SAND CREEK RESTORATION

PCD PROJECT NUMBER: CDR-20-004

PUBLIC IMPROVEMENT CONSTRUCTION PLANS

EPC STORMWATER REVIEW COMMENTS
 IN ORANGE BOXES WITH BLACK TEXT

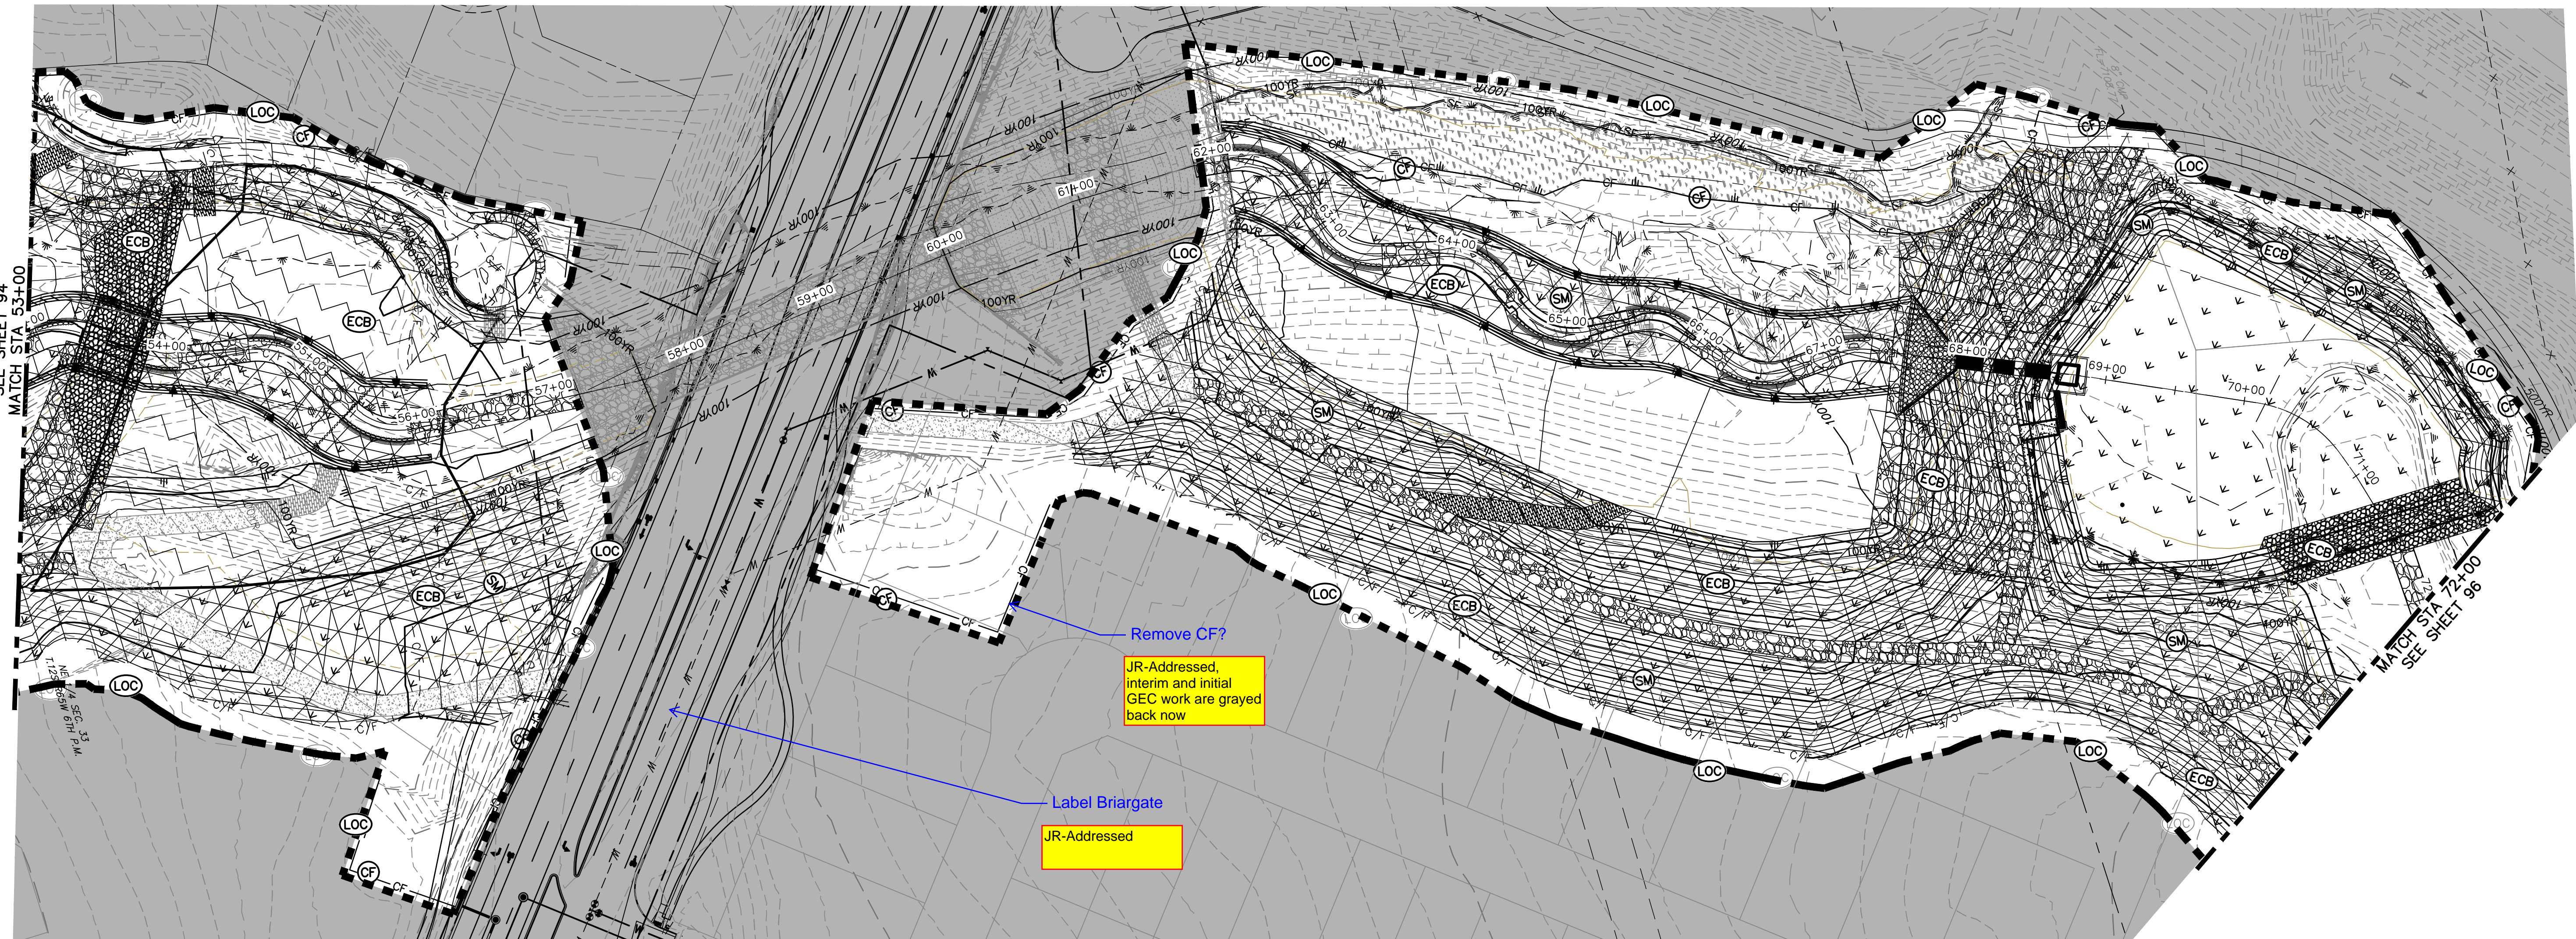
show location on key

JR-Addressed
